To: File, DILTS RANCH COMPANY, OBJECTION TO NPDES PERMIT NO.  
WY0049255, Docket No. 03-3800

Re: Closing DILTS RANCH COMPANY, OBJECTION TO NPDES PERMIT NO.  
WY0049255, Docket No. 03-3800

Re: **Objection to NPDES Permit No. WY0049255**  
Phillips Petroleum Company  
Antelope Creek Water System  
Converse County, Wyoming

EXHIBIT 1-B - Winter flooding of CBM water  
caused by ice jams

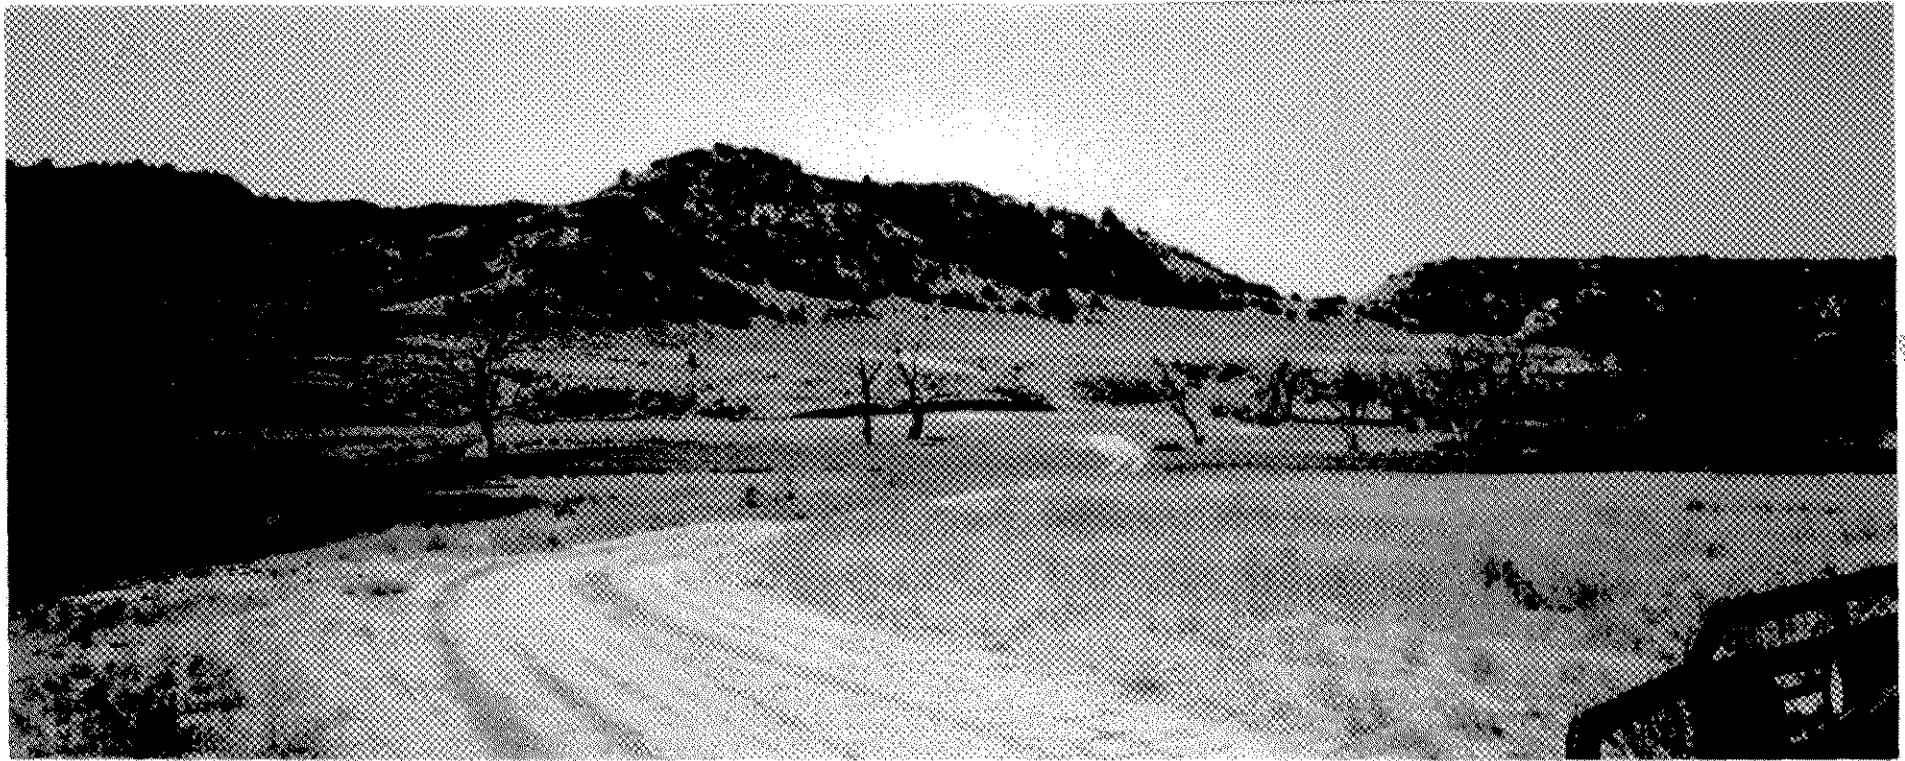
1. **Phillips Has Not Adequately Considered the Effect of Ice Jams.** By turning Antelope Creek and sections of the Cheyenne River from ephemeral streams into perennial streams, the possibility exists that during winter and spring conditions, ice jams will cause produced CBM water to spread out across fields and pastures. For illustrative purposes, attached as **Exhibits 1A and 1B** are photographs of flooding of produced CBM water caused by ice jams in the Spotted Horse Creek drainage in northeastern Wyoming in January 2001. The possible adverse results from such ice jams include the pooling of poor quality produced water on fields and pastures with resulting damage to soils and vegetation; loss of or injury to livestock either as a result of slipping on ice or getting bogged down; and potential damage to cottonwood trees resulting from long-term inundation. Attached as **Exhibits 2A and 2B** are photographs of the same fields in Spotted Horse Creek subjected to the flooding depicted on Exhibits 1A and 1B. In those fields, cottonwood trees have been killed as a direct result of flooding of produced CBM water. It is certainly possible that the same results may occur in the Antelope Creek and Cheyenne River drainages.

In its application (pages 22 and 23; Appendix E - Riparian Vegetation Analysis, page 3), Phillips leaves the problem of ice jamming virtually unaddressed, except to state that it will be prepared to break up ice in order to prevent pooling and potential problems. As a practical matter, the Dilts Ranch Company questions whether Phillips has the necessary
